Notice of Modification

Section 75W of the *Environmental Planning and Assessment Act 1979*

Project Approval 08_0135 for the Moolarben Coal Project Stage 2, granted by the Planning and Assessment Commission Minister for Planning on 30 January 2015.

Figure 2.1 – Indicative General Arrangement

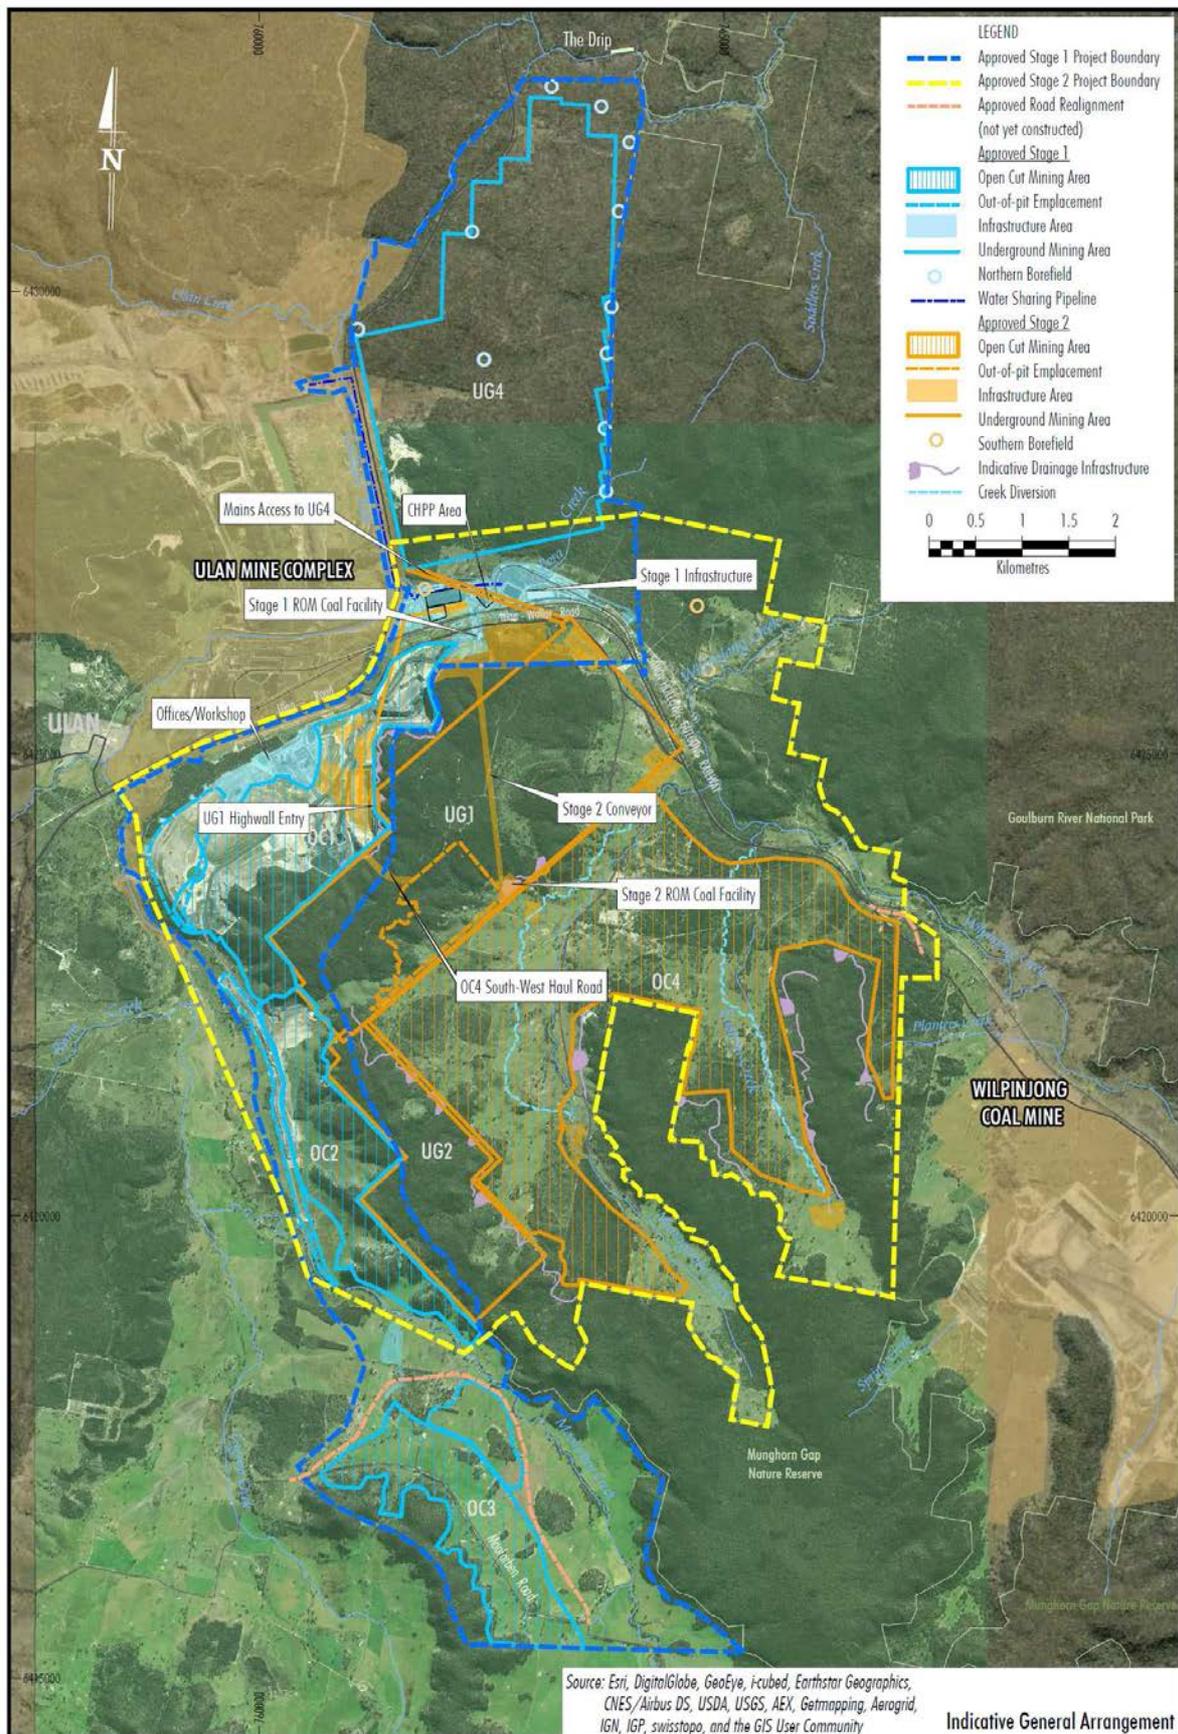
20. In Appendix 2 replace all figures with the following:

Figure 4.1 – Natural and Heritage Features

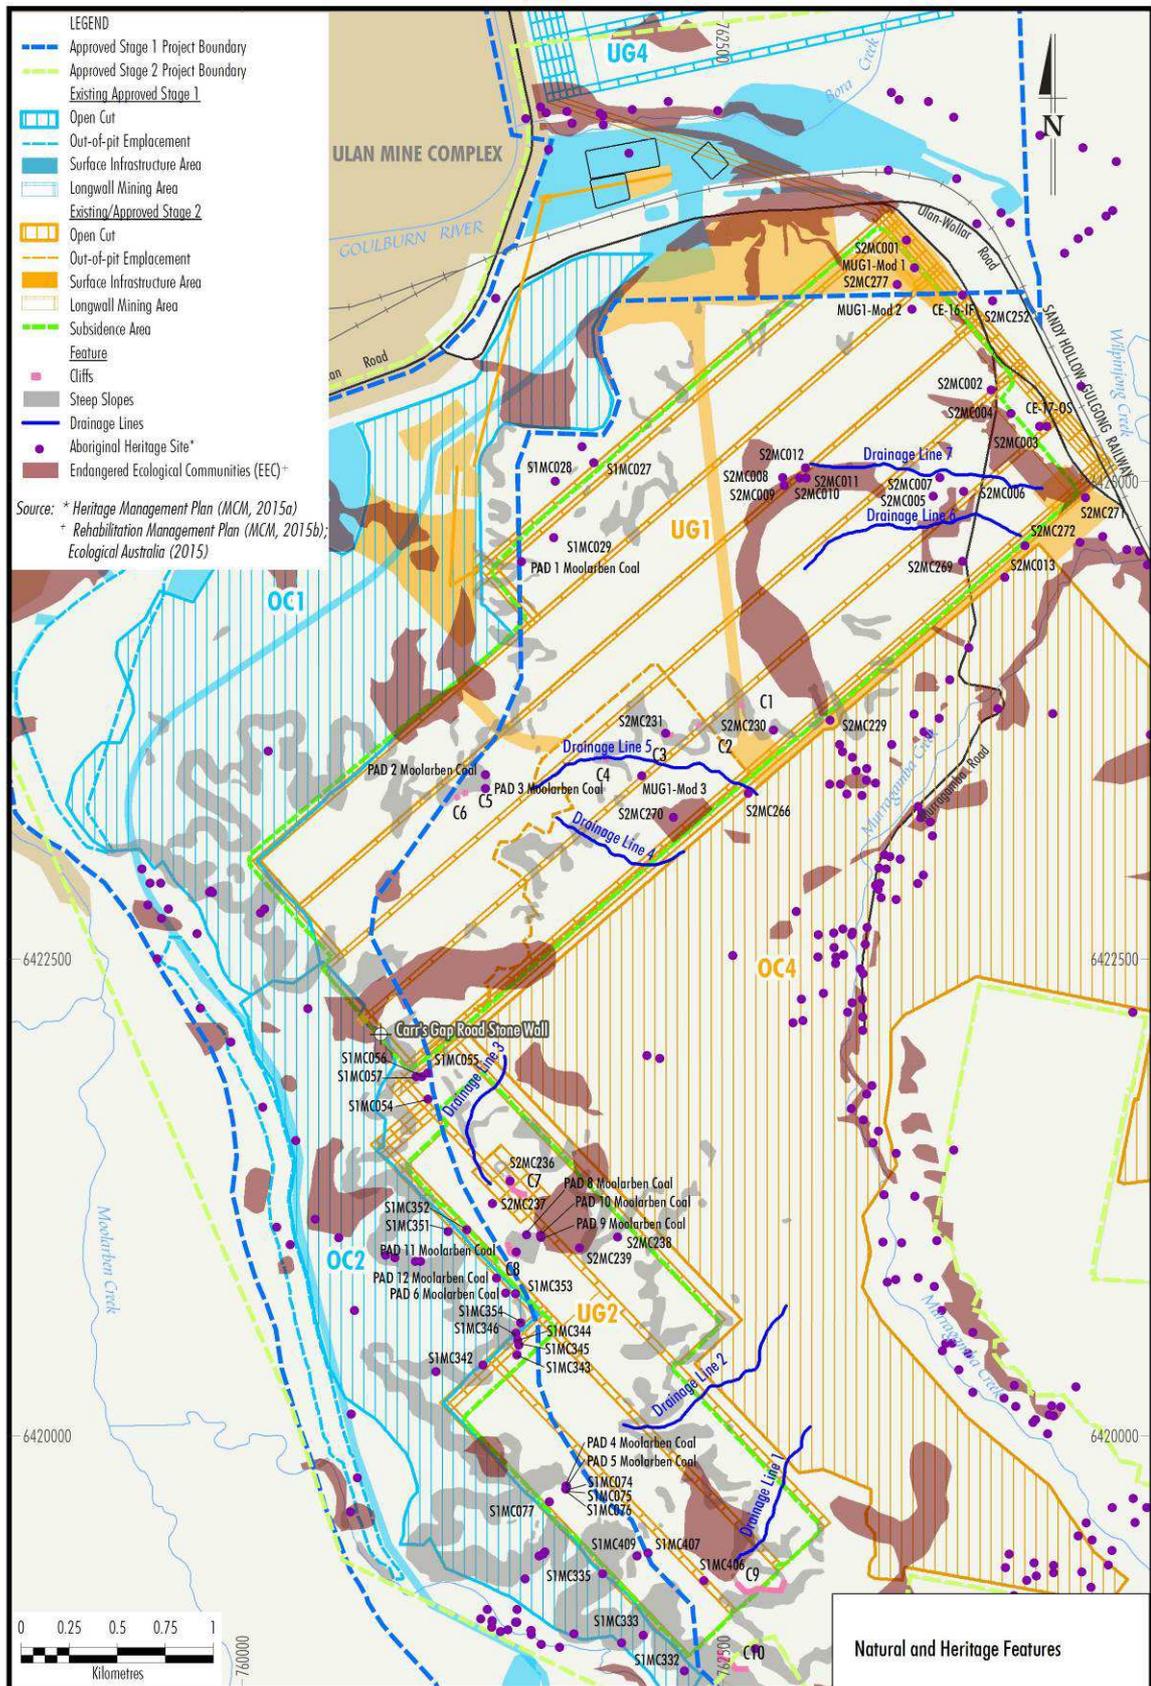
21. In Appendix 4 replace all figures with the following:
